ADDENDUM No. 02

Subject: Feltonville Intermediate
Fire Alarm System Replacement
SDP Contract No. B-016c of 2020/2021

Location: Feltonville Intermediate
238 East Wyoming Ave.
Philadelphia PA 19120

This Addendum dated October 06, 2021 shall modify and become part of the Contract Documents for the work of this project. Any items not mentioned herein, or affected by, shall be performed strictly in accordance with the original documents.

A FIRE ALARM FIRST FLOOR NEW WORK PLAN
E-104 SCALE: 1/8" = 1'-0"

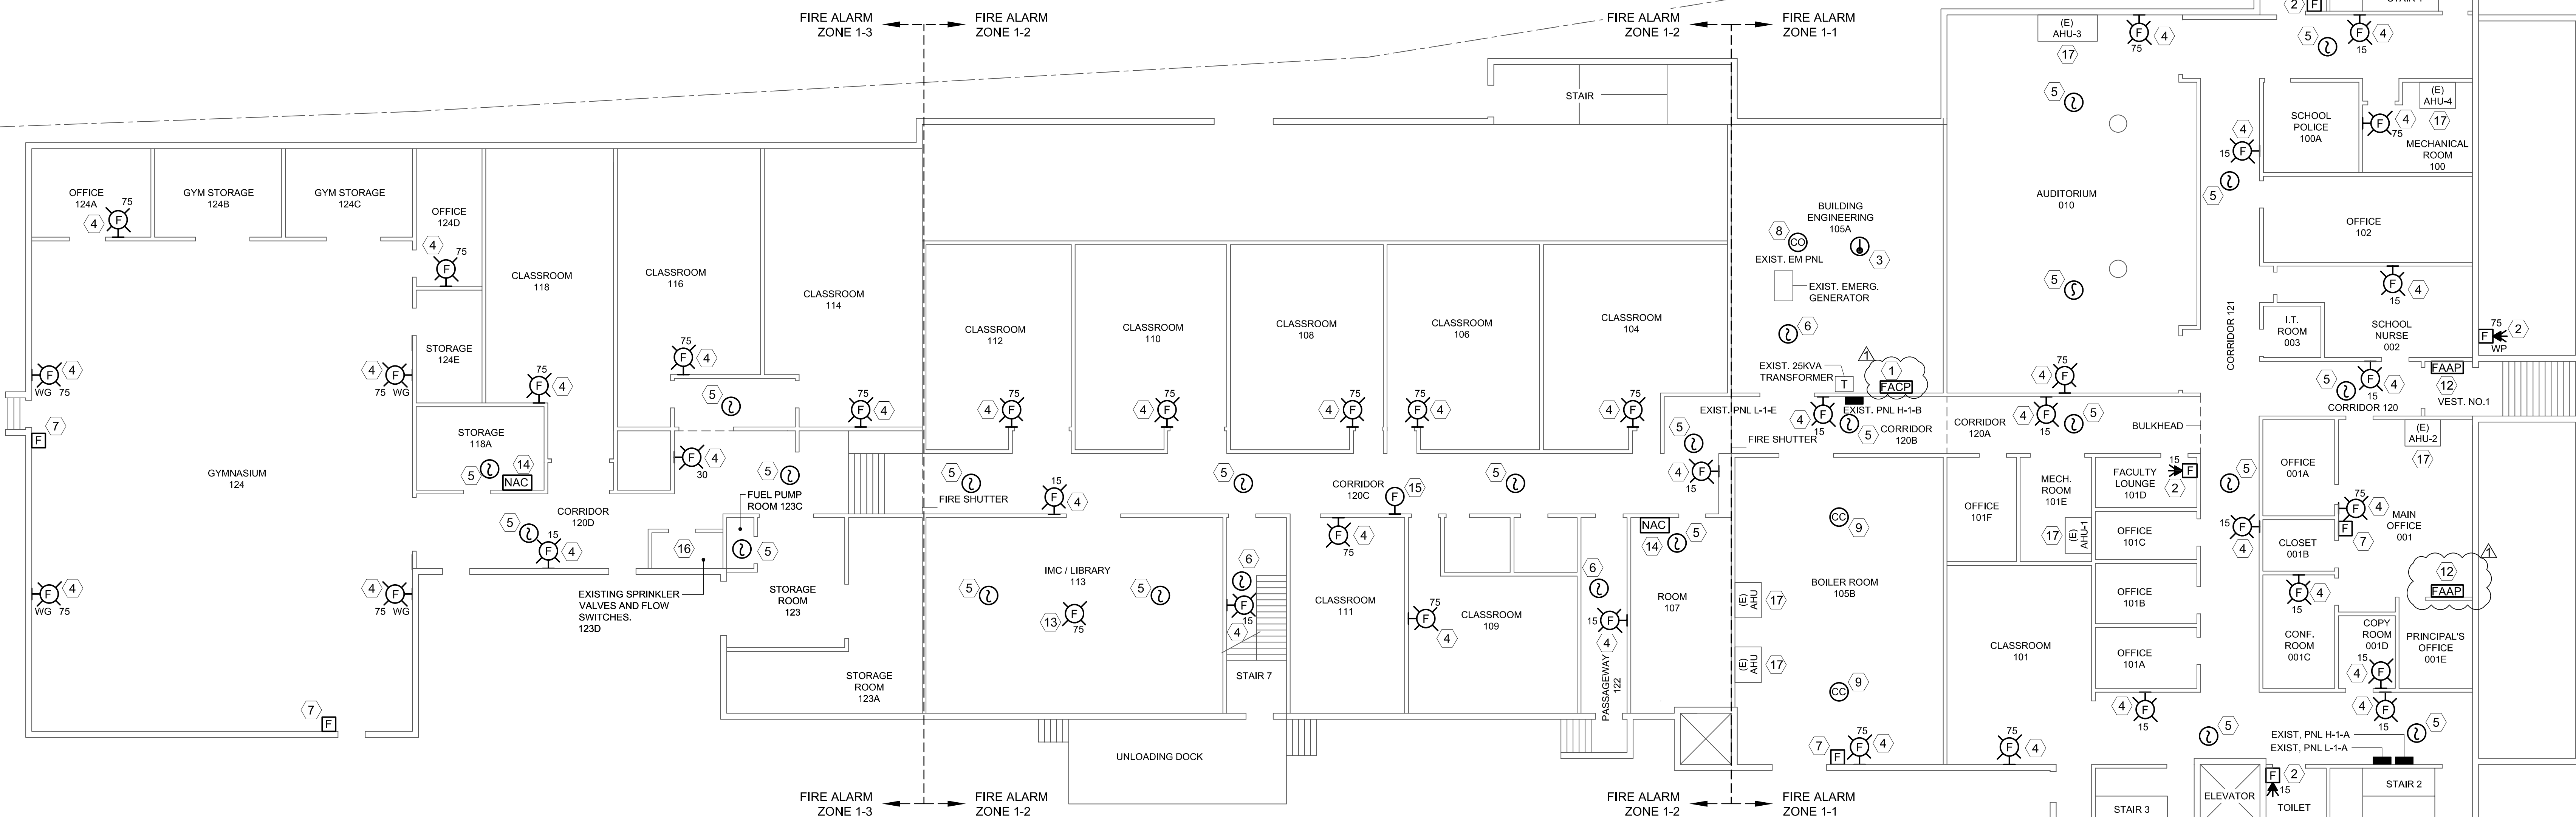
Question #1: Is an annunciator required in the Main Office, Room001?

Question #4: General sheet note D on E-104 states to paint all fire alarm conduit red. Please confirm painted red conduit is not required.

Response: Provide an annunciator in the Main Office and the Fire department entrance. Refer to attached revised Sheet E-104. Coordinate final locations with SDP project manager.

Response: Per SDP, painted red conduit is NOT required.
